# Access Compliance Report

### (Curb Ramps)

Intersection ID: 30018	Main Street: W MALLARD CREEK CHURCH RD	Cross Street: BERKELEY PLACE DR	Location: SE
ADA ID: 653CCD8390C7	Ramp Type: Perpendicular	Initial Pass/Fail: Fail	Overall Compliance: No
Severity Score: 12.5			
Codes/Mitigation Info/Possible Solution		Field Measurements/Component Compliance

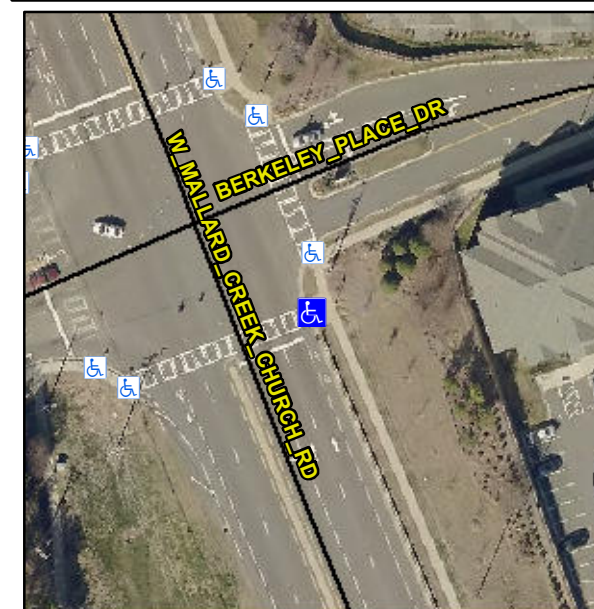
**Remove & Replace Entire Ramp.**

**R304.2.2**

Compliance	Description	Data	Compliance	Description	Data
N/A	Ramp Length (in)	86.0	No	Ramp Slope (%)	9.9
Yes	Ramp Width (in)	48.0	Yes	Ramp XSlope (%)	0.1
N/A	Flare Type LT	N/A	N/A	Flare Type RT	N/A
N/A	Flare Slope LT (%)	N/A	N/A	Flare Slope RT (%)	N/A
N/A	Flare Traversable LT?	N/A	N/A	Flare Traversable RT?	N/A
N/A	Landing Length (in)	N/A	N/A	DWS Provided?	N/A
N/A	Landing Width (in)	N/A	N/A	DWS Contrast?	N/A
N/A	Landing Slope (%)	N/A	N/A	DWS Length (in)	N/A
N/A	Landing X Slope (%)	N/A	N/A	DWS Full Width?	N/A
N/A	Landing Curb? (Y/N)	N/A	N/A	DWS Offset (in)	N/A
N/A	Shared Landing?	N/A			
N/A	Gutter Ponding?	N/A	N/A	Gutter Slope (%)	N/A
N/A	Gutter Lip Ht (in)	N/A	N/A	Gutter X Slope (%)	N/A
N/A	Painted X Walk1?	Yes	N/A	Painted X Walk2?	N/A
	X Walk 1 Direction	To W		X Walk 2 Direction	N/A
N/A	X Walk 1 Width (in)	102.5	N/A	X Walk 2 Width (in)	N/A
	X Walk 1 Slope (%)	2.9		X Walk 2 Slope (%)	N/A
	X Walk 1 X Slope (%)	1.3		X Walk 2 X Slope (%)	N/A
